Original Application No. 162 of 2021(SZ)

Tribunal on its own motion Suo Motu based
on the News item published in The Times of India Newspaper,
Chennai Edition Dt.01.07.2021, "under caption"
Another Pipeline leak at Ennore Power Plant".

REPORT OF JOINT COMMITTEE IN COMPLIANCE TO
HON'BLE NATIONAL GREEN TRIBUNAL(SZ), CHENNAI
ORDER DATED 24/09/2021 IN O.A.NO.162 OF 2021

Construction works for supporting structures stopped by NCTPS-III

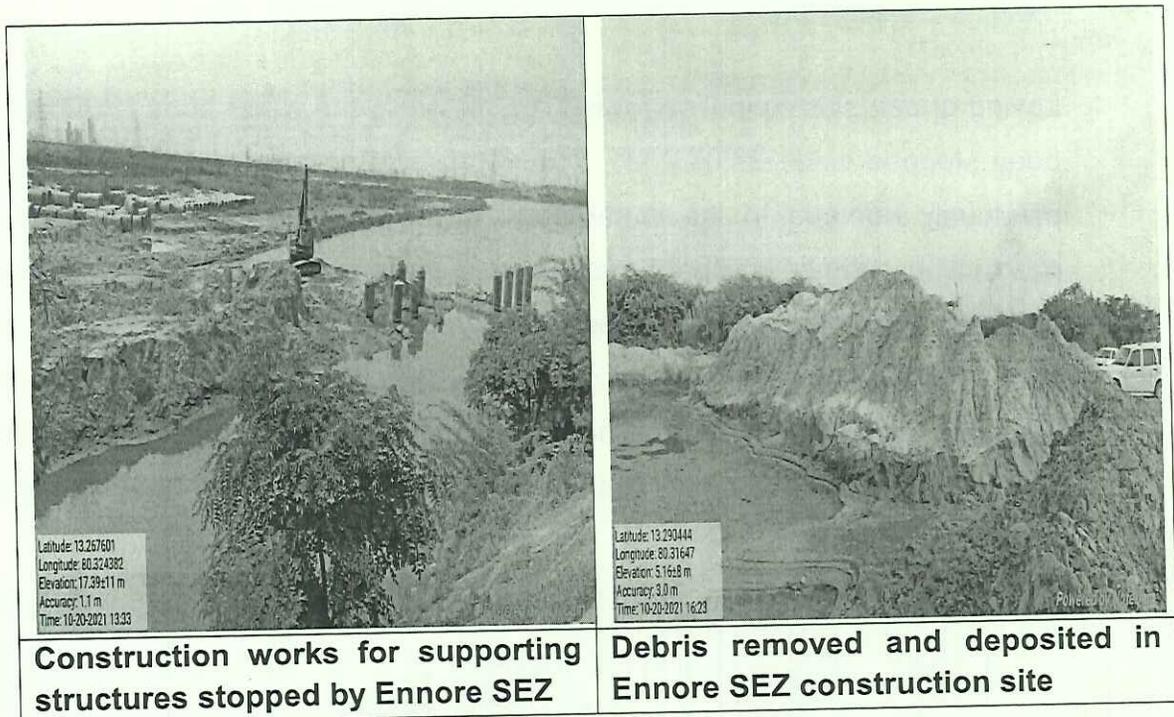
1. Laying of ash slurry pipeline for NCTPS III within the water body (CRZ area) has been stopped since 27.07.2021. The debris and construction material that were previously dumped in the water body is removed and presently there is no obstruction and fishing boats are sailing in the water body. The debris that were removed from the water body are deposited around 100m away from the river bank. Though the debris are not obstructing flow of water but during rainy season it may be washed into the river, hence committee suggests that the debris may be utilized or disposed safely in M/s NCTPS own land away from the water body by November 30, 2021.

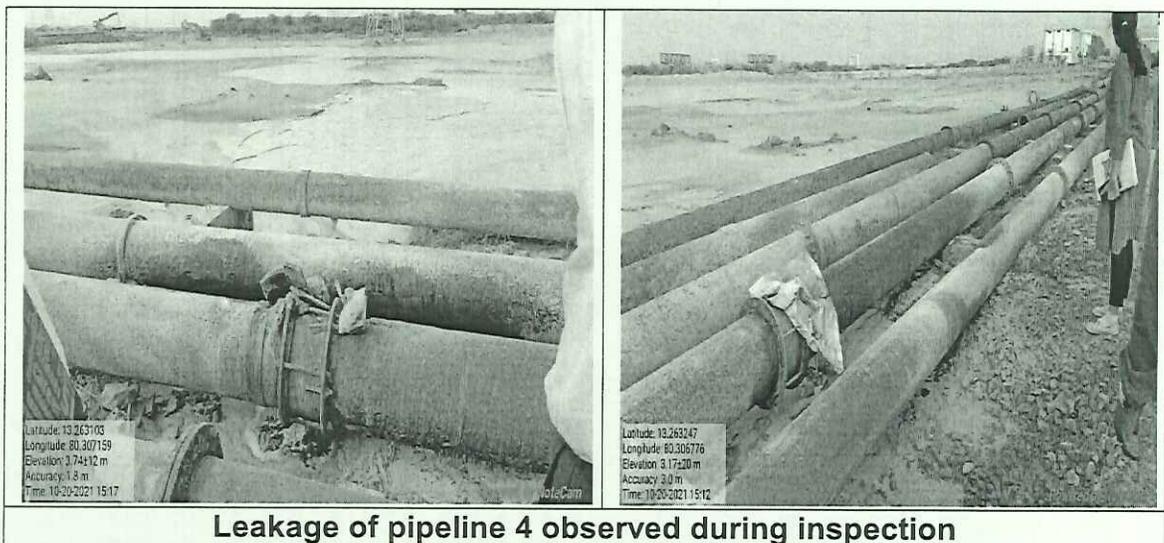
4. Although minor leakages of ash slurry pipeline -4, at two places, were noticed at the time of inspection, no other major leakages were noticed. The unit is taking steps to arrest the leakages immediately so that the surrounding area is not contaminated. Measures taken by M/s NCTPS for early detection of leakages are as follows:

- A dedicated patrol team of 12 members (two vehicles) is appointed by M/s NCTPS to inspect/ watch the pipelines for any leakages. The patrol team is working 24x7.
- Soon after the leakages are detected, the pumping of ash slurry is stopped.
- The surrounding area is cleaned and the quantity of fly ash leaked is removed and transferred to ash dyke.
- During the meeting, the committee learnt that the top Management starting from Chief Engineer who is heading M/s NCTPS stage-I and senior officers are closely checking the records for leakages and to immediately take measures for arresting the leakages in the pipes

Removal and transportation of old worn out pipes

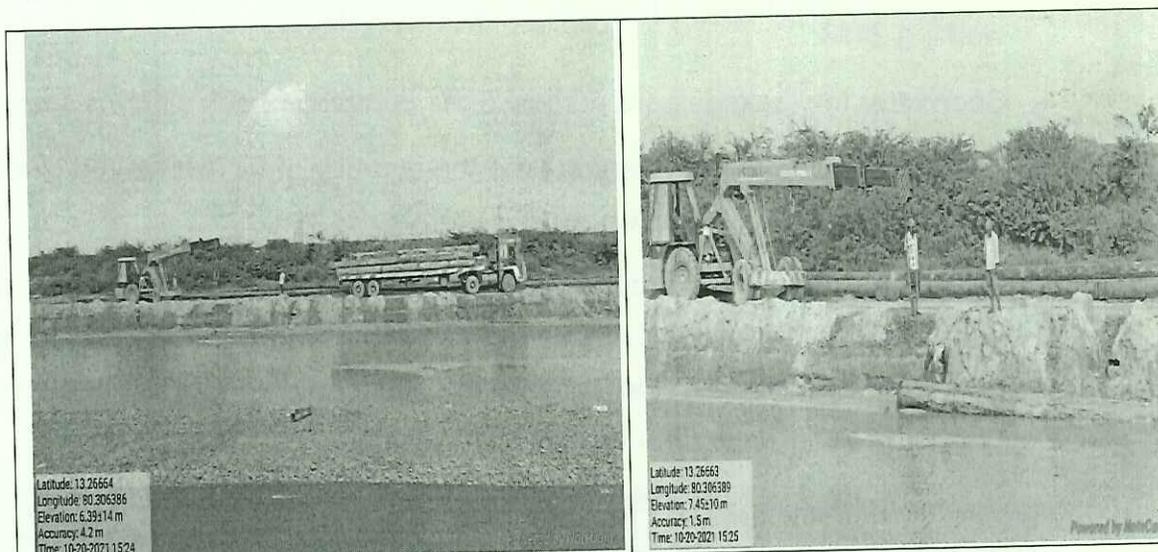
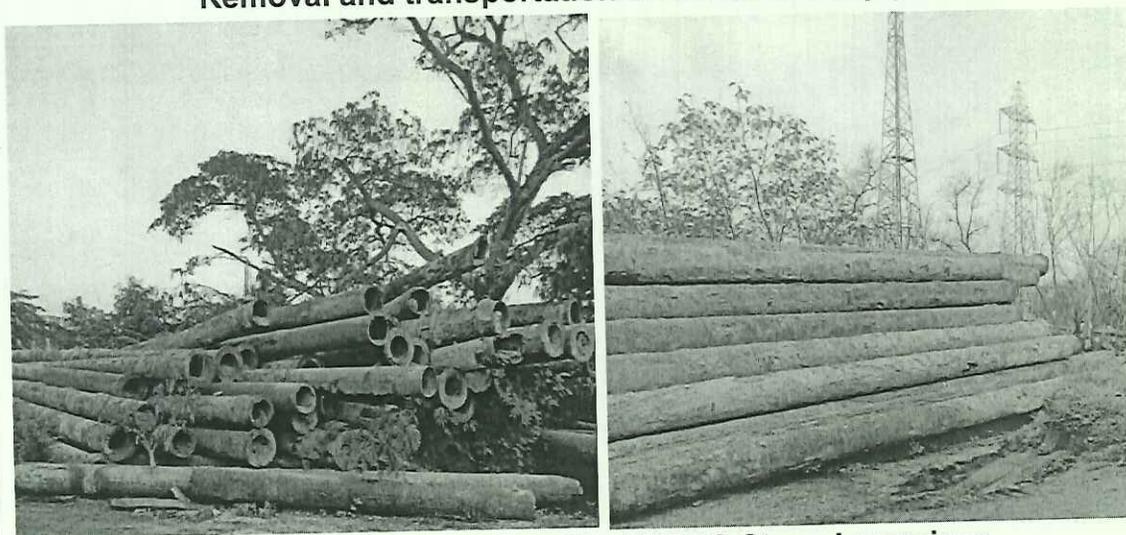
5. Removal of earlier deposition of ash from the leaky pipeline areas and transportation of the same to ash pond was going on.
6. Previously when the leaking portion of the pipes were replaced with new ones, the old pipes were left near point of replacement itself. Due to these, many old rusted pipelines were found laying along the pipeline route. In compliance to Hon'ble NGT orders, M/s NCTPS Stage-I started removing of old pipes and same were being collected and transported to the storage yard inside the NCTPS Stage I

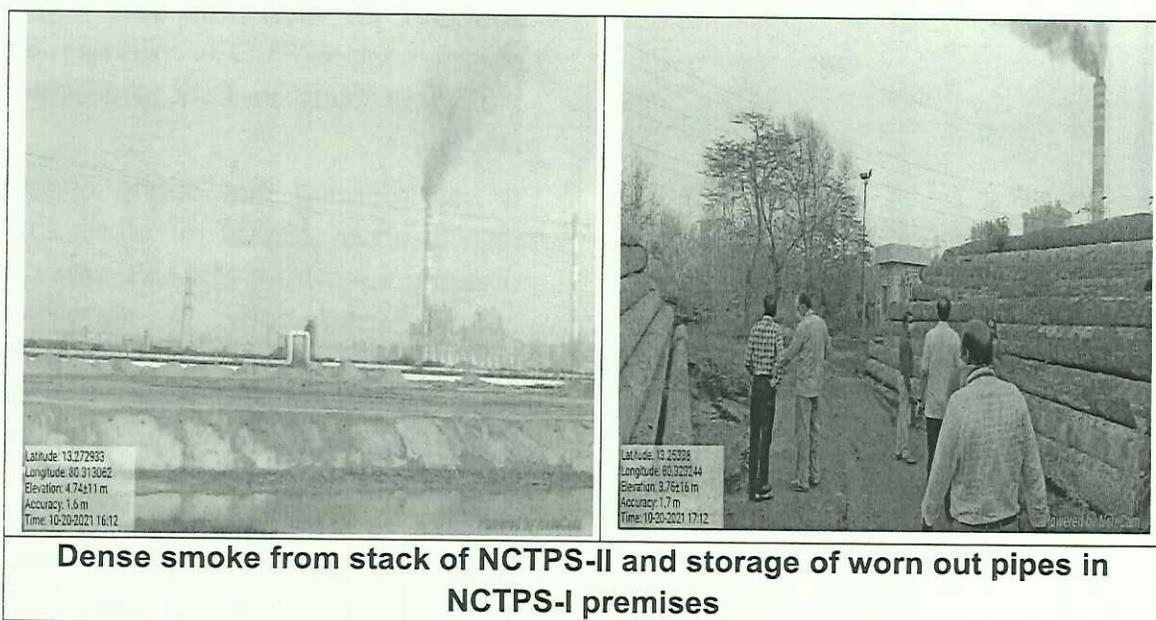
- Dense flue gas emission was noticed from the boiler stack of NCTPS Stage II at the time of inspection. Though the unit has installed Online Continuous Emission monitoring system to monitor PM, SO_x and NO_x emitted from the flue gas, it was observed that as per OCEMS readings, real time data is not transmitted to CPCB/ TNPCB and there is time delay. The committee observed that SMS alerts are

generated whenever exceedances are observed however the unit is yet to take corrective actions.
